Hanoi City Ring Road 3 Construction Project, Section Mai Dich –
South Thang Long

DESIGN REPORT OF SOUTH THANG LONG
INTERCHANGE

Date: 31st March 2016

2. Approved Design of South Thang Long Interchange (F/S)

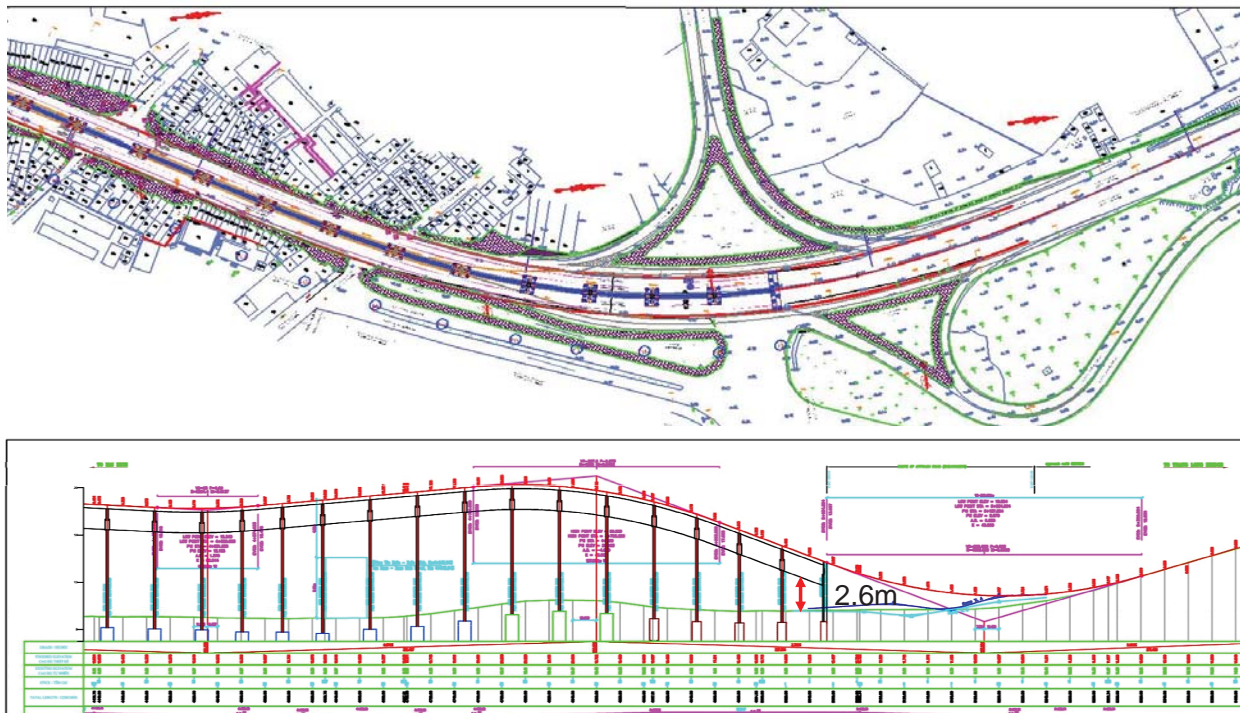
In F/S of the Project, there was analysis of 3 Alternatives for the interchange: Alternative 1 connects to existing road before South Thang Long Interchange, 2 is the approved Alternative and 3 is the extension of the viaduct over the existing intersection. However, Alternatives 1 and 3 were not selected, because of large quantity of land acquisition. According to the TOR, the DD Consultant is responsible to review F/S and based on the reviewed result of the F/S, there are some outstanding matters on designed Alternative of South Thang Long Interchange as follows:

- This Alternative does not satisfy design requirement for connecting to South Thang Long and Nguyen Hoang Ton Intersections (according to the Plan) as well as the convenient connection with urban roads entering and exiting the expressway.
- The current arrangement of on/off ramps connecting to Thang Long Bridge will concentrate big number of vehicles moving in the urban road, which will cause traffic congestion in the urban road and not bring into full play of the serviceability of the expressway.
- The non-arrangement of on/off ramps in South Side of the Interchange will not be convenient for connecting the traffic from the expressway to large urban areas and to dockyards along the South River Bank or vice versa. When the West Thang Long Road has been constructed, the traffic demand in this area is large.

(4) Adjusted South Thang Long Interchange

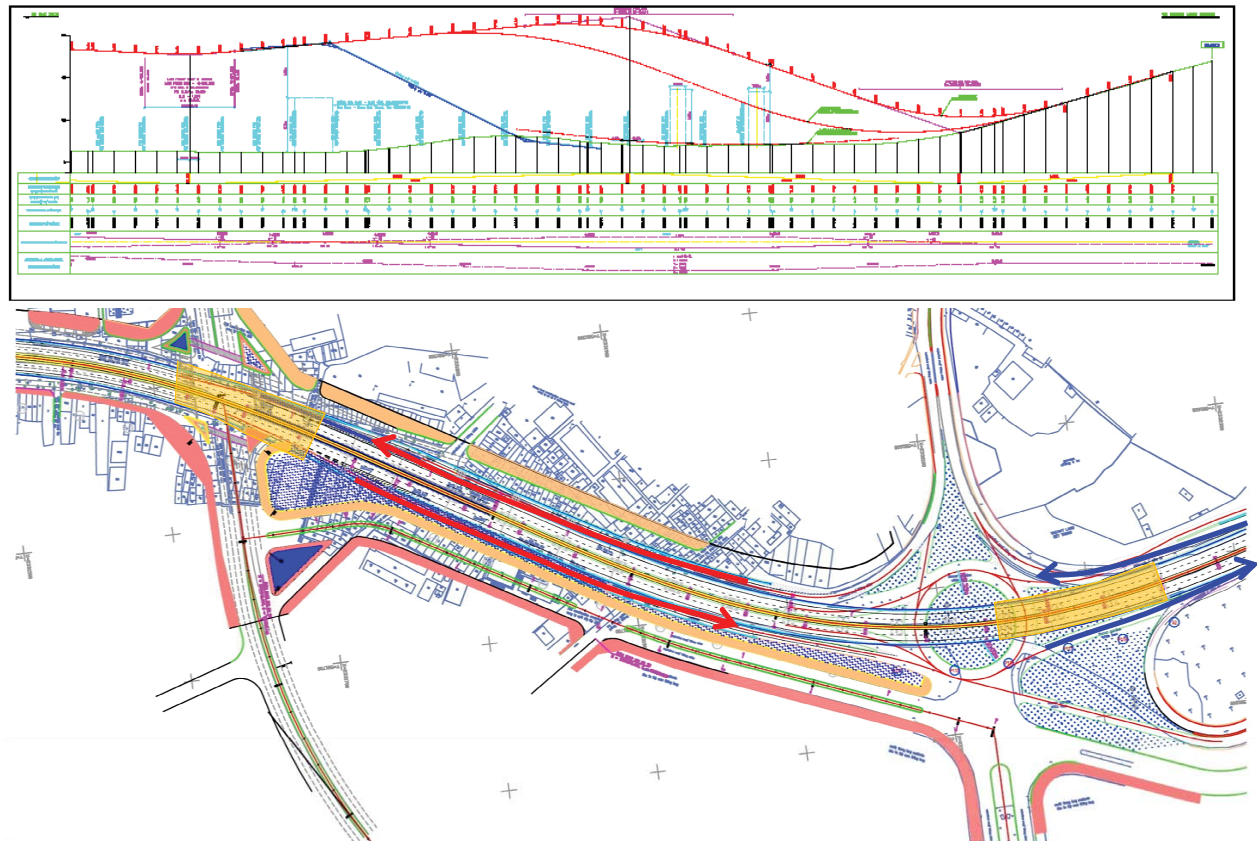
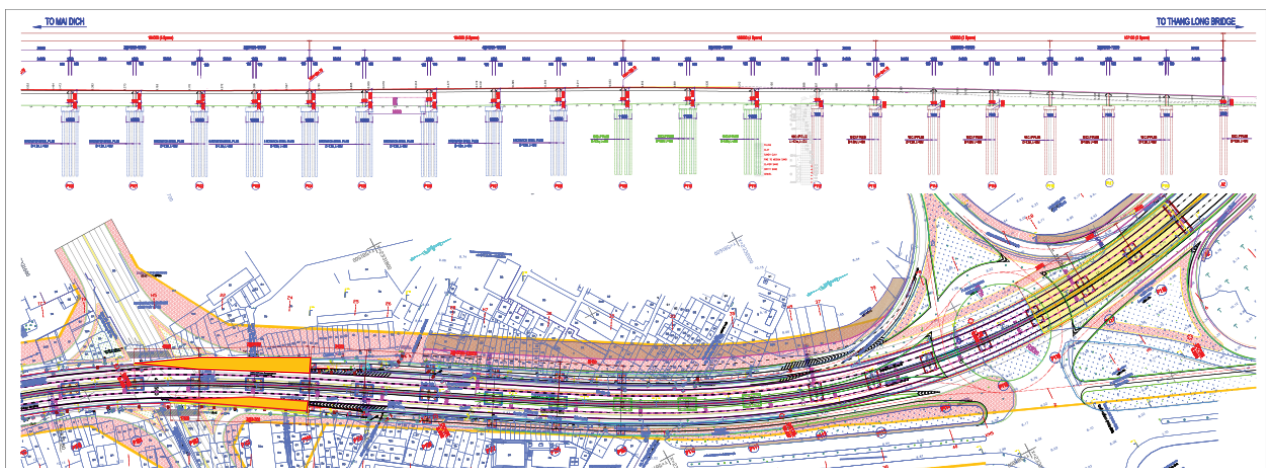
- Raise profile of the viaduct and extend the viaduct for about 107.1m (3 Super-T Girder Spans with length of 36m) to ensure vertical clearance and arrange an at-grade intersection under the viaduct with a roundabout of R=30m matching with the plan of the existing intersection;
- Readjust the retaining wall section of Abutment A2 of the viaduct, adjust 2 on/off ramps in North Side of the Interchange for a smooth connection with Thang Long Bridge Approach (going towards North Side); In the off ramp (left side) it is required to supplement RC retaining wall for shoulder to minimize land acquisition.
- South Side of the Interchange is supplemented with 2 on/off ramps for traffic connection with dockyard area in Red River Bank, Ciputra Urban Area and the existing Residential Areas along the river bank.

- (ii) Recommend and consider the staged construction plan in phases suitable to land acquisition condition and budget of the project, viz:
 - Phase 1: Raise profile, extend 3 spans of main bridge; adjust on/off ramps of Thang Long Bridge; Widen main bridge, the section changing width from 24m~33m (from P101 – P104) for future connection with on/off ramps constructed in Phase 2. This area is basically within the existing plan of Pham Van Dong Road, not requires land acquisition.

- Phase 2: Widen the main bridge, section from P104 – P105 ; Construct 2 on/off ramps in South Side of the Interchange, direction from Mai Dich to Thang Long Bridge; Adjust plan of Urban Road (when widening Pham Van Dong Road) suitable to plan of the Piers constructed in Phase 1.
